RAI No.	Section	Issue	Regulatory Link	Discussion	Path Forward
CH-10	Section 5.2 Waste Characterization, Section 6.4 of HDP-TBD-WM-906	Portion of Area 1 that is excluded	10CFR20.2002(a)	The northeast portion of Area 1 and Area 5 will be excluded from this request, but the exact boundary and methods for keeping the materials from intermixing with materials that will be sent to USEI are not described.	Provide a detailed description (e.g., enlarged map with discernable boundaries) that delineates the boundaries of the areas that will be excluded from this request. Describe the procedures for ensuring that the excluded wastes will not be intermixed with other wastes prior to shipment.
<b>Response Summary:</b> A figure showing the areas excluded from this request is provided.					
<b>Response Detail:</b> The attached Figure A to RAI CH-10 is an actual picture of the slabs. During the application of fixative to the surface of the slabs, different colors were added to the fixative to denote areas that were included (green) and excluded (blue). The same type of identification and control measures (e.g., separate staging areas and containers) used to segregate burial pit soil/debris that do

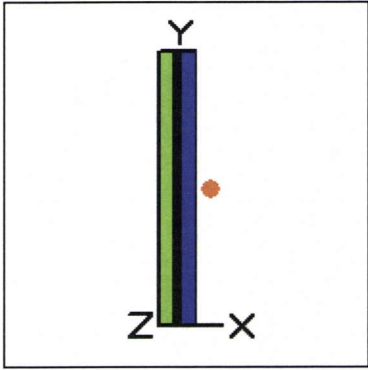
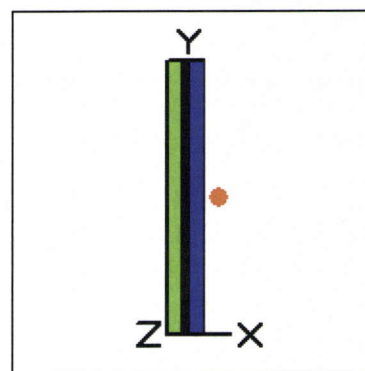
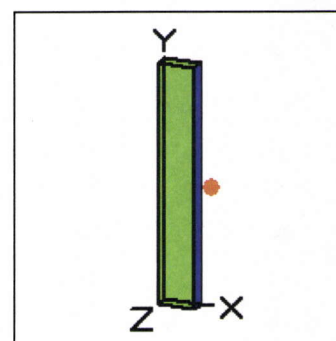
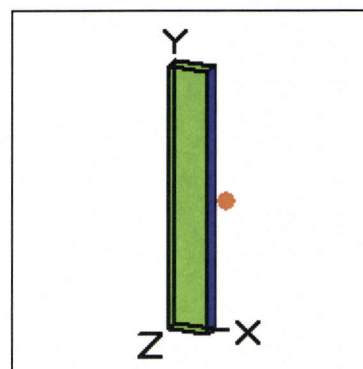
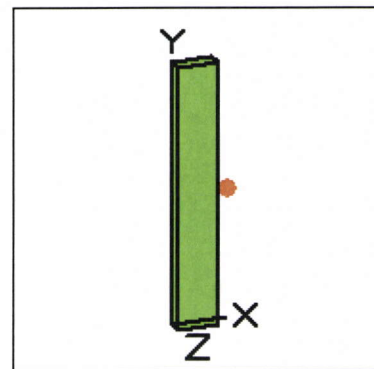
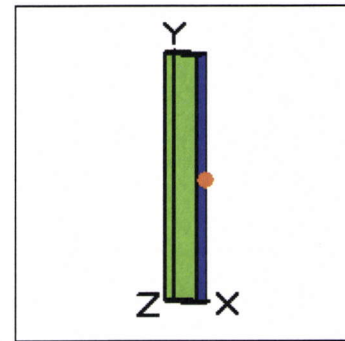
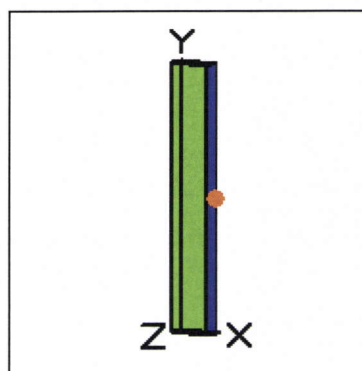
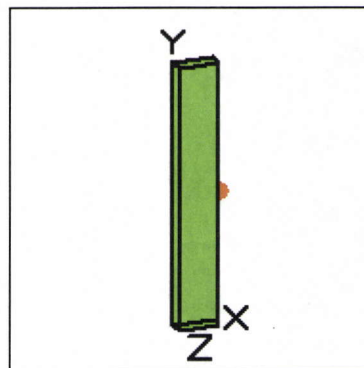
RAI No.	Section	Issue	Regulatory Link	Discussion	Path Forward
CH-13	Section 6	MicroShield <sup>®1</sup> modeling of worker dose	10CFR20.2002(d)	<p>Some of the parameters used in the MicroShield calculations for the worker dose differ from those used by Westinghouse in the May 2009 20.2002 request and it is not clear why:</p> <ul style="list-style-type: none"> <li>• The orientation of the excavator and the stabilization workers in relation to the gondola is different in this request</li> <li>• The shield is used for determining buildup in the excavator and stabilization worker scenarios in the current request, while the source was used for buildup in the previous request</li> <li>• The thickness of the shielding for the gondola surveyor is less in the current request (0.794 cm) than in the previous one (2.53 cm)</li> </ul> <p>Also, note that the geometry assumed for the stabilization tank as the source of exposure to the stabilization worker in both this HDP request and the May 2009 request was assumed to be gondola shaped. This differs from the geometry (a cube) assumed in 20.2002 requests submitted by other licensees also involving shipments for disposal at USEI. Given that the disposal site and process is the same for these cases, no explanation was provided as to the basis for the differences in source configurations.</p>	<p>Describe the basis for changing the values for these parameters for these scenarios from the May 2009 submittal.</p> <p>The Microshield<sup>®</sup> model utilized by Westinghouse to calculate the dose to the stabilization operator assumed the source was shaped as a gondola and that the operator was located 2 m away from the source. Westinghouse should provide justification for the assumed source shape in the Hematite analysis versus the cube shape assumed for other disposals at USEI.</p>

<p><b>Response Summary:</b> The justifications for changing the three identified parameters are provided. These factors did not change the bounding dose, which continues to be the excavation operator.</p>					
<p><b>Response Detail:</b></p> <p><i>The orientation of the excavator and the stabilization workers in relation to the gondola is different in this request</i> The orientation of the excavator and the stabilization workers has been revised to be consistent with the initial request. See response pertaining to source buildup below.</p> <p><i>The shield is used for determining buildup in the excavator and stabilization worker scenarios in the current request, while the source was used for buildup in the previous request</i> The source is the more appropriate selection for the buildup material based on the number of mean free path (MFP) lengths associated with</p>

RAI No.	Section	Issue	Regulatory Link	Discussion	Path Forward
				<p>it as compared to the shield. The use of the shield for building up in the current submittal is erroneous.</p> <p>Dose factors for the excavation operator (using the source as the buildup material) were recalculated (MicroShield results attached). This recalculation also includes a modification to the exposure geometry for the excavation / stabilization operator, gondola surveyor and transportation worker. In the original submittal the dose points for each of these scenarios were placed on the incorrect plane. These changes result in a decrease in the external exposure to the transportation worker and gondola surveyor and a slight increase in dose to the excavator operator / stabilization worker. The increase in external dose to the excavation operator (9.4E-4 mrem/yr to 2.7E-3 mrem/yr) is insignificant in comparison to the accompanying internal dose which is assigned (1.8E-1 mrem/yr). The increase in dose to the stabilization operator is also insignificant (3.14E-5 mrem/yr to 9.13E-5 mrem/yr) when compared to the assigned internal dose (6.11E-3 mrem/yr).</p> <p><i>The thickness of the shielding for the gondola surveyor is less in the current request (0.794 cm) than in the previous one (2.53 cm)</i></p> <p>The shield thickness for the gondola surveyor in the current request is based on the thickness of the railcar wall (0.794 cm) as opposed to the prior request in which the same shielding was afforded the surveyor as the excavator operator. The assumptions in the current request more accurately reflect the actual conditions in which the surveyor is oriented to the side of the car and the excavation operator is above the car. The one inch shielding afforded the excavation operator is based on the deck thickness for the excavation gantry.</p> <p>Dose factors for the gondola surveyor and excavator operator for the prior 20.2002 request were also recalculated (MicroShield results attached). There is a slight increase in external dose to the gondola surveyor (1.2E-3 mrem to 2.5E-3 mrem) and a slight decrease in external dose to the excavator operator (8.4E-4 mrem to 4.2E-4). These changes do not change the results of the assessment which reported the dose to the truck driver (which is unaffected by these changes) as bounding.</p> <p><i>Westinghouse should provide justification for the assumed source shape in the Hematite analysis versus the cube shape assumed for other disposals at USEI</i></p> <p>The difference in source shape in the external dose model used for the stabilization operator is due to the use of gondola railcars for waste shipment by HDP versus trucks by other applicants.</p>
